ITEM #	QTY	NEWMAR #	DESCRIPTION
1	1	136787	14 GA STEEL PAINTED BLACK

NEWMAR CORP P.O. Box 30, Nappanee, IN. 46550 UNITS: INCHES TITLE BLOCK: 1-4FULTB	Model:	Sheet	Drawn by:	Checked by:	Revision: ADDED BT'S TO PRINT (DUE TO 28" VIZIO NO LONGER AVAILABLE) (ECO #469)	By: R. M.
	BT/BS/CS CA, VL/VT/DS DP (SEE INDEX)	1 OF 1	R. W.	J. S.		Date: 11/9/16
	Title: TV BRACKET FOR 32" VIZIO, 32" SONY	I.D. # 2017\COMPONENTS\TV_BRACKETS\32_4	Date: 10/12/16	Date: 10/12/16	Revision: New TV bracket; Moved Vizio TV holes down 3/8" and added 3" x 2 1/2" hole due to new TV model (ECO #437)	By: R. W.
						Date: 10/12/16

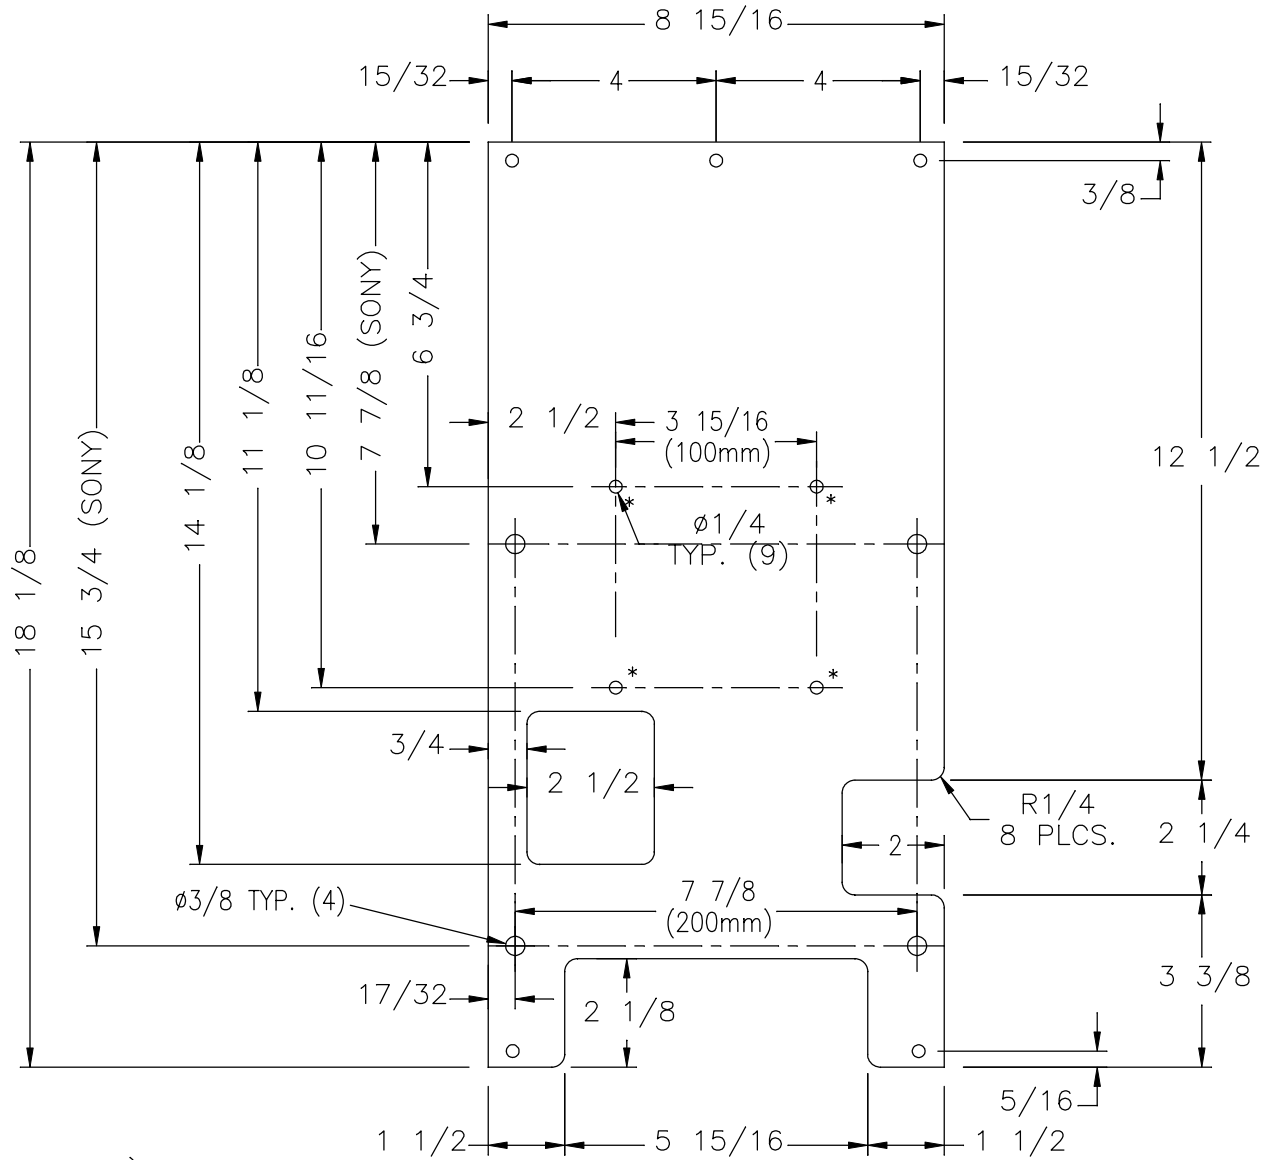
*NOTE: VIZIO REQUIRES LONGER MOUNTING SCREWS (M-4-16; ACE HDWR. PART#43139D)

NOTE: ALL HOLES TO BE 1/4" DIAMETER, EXCEPT (4) SONY MOUNTING HOLES WHICH WILL BE 3/8" DIAMETER.
